## **TEAGLE METAL®**

Job: **QU02705 - PRODUCTION SET\_04162025 -** 1246420 T04

Quality Line Truss Co., LLC 34593 S 4350 RD Address 2 Adair, OK 74330 Truss: T04

Job Name: QU02705 - PRODUCTION

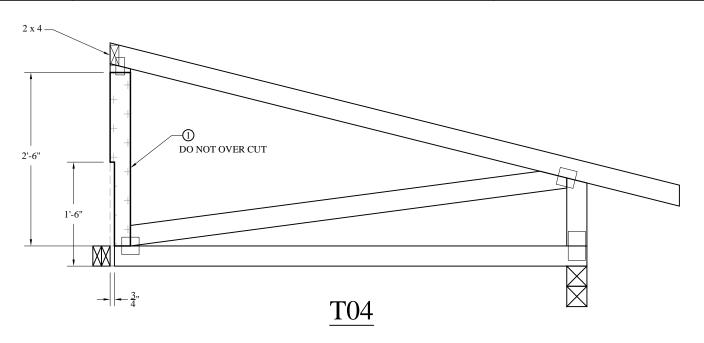
### PROBLEM:

LEFT END WEB HAS 1'-6" TALL NOTCH REMOVING 3/4" AS SHOWN. NOTCH IS OVER CUT. A 2 x 4 IS PRESENT RUNNING OUT-OF-PLANE FOR SOME TRUSSES AS SHOWN. TOENAIL BEARING REMAINS EFFECTIVE.

## SOLUTION:

1) ATTACH (1) 2 x 4 SYP-#1 SCAB TO TRUSS AS SHOWN WITH CONSTRUCTION GRADE WATERPROOF GLUE (PL400 OR BETTER) AND (2) STAGGERED ROWS OF (.131 x 3") COMMON NAILS, OR EQUIVALENT, AT 4" O.C., ALONG UNDAMAGED LENGTH OF WEB. ALONG DAMAGED LENGTH OF WEB, USE (1) ROW. REMOVE PORTION OF SCAB MATCHING NOTCH IN LOCATION AND DIMENSIONS, IF NEEDED, CREATING A CLEAN AND STRAIGHT CUT. DO NOT OVER CUT.
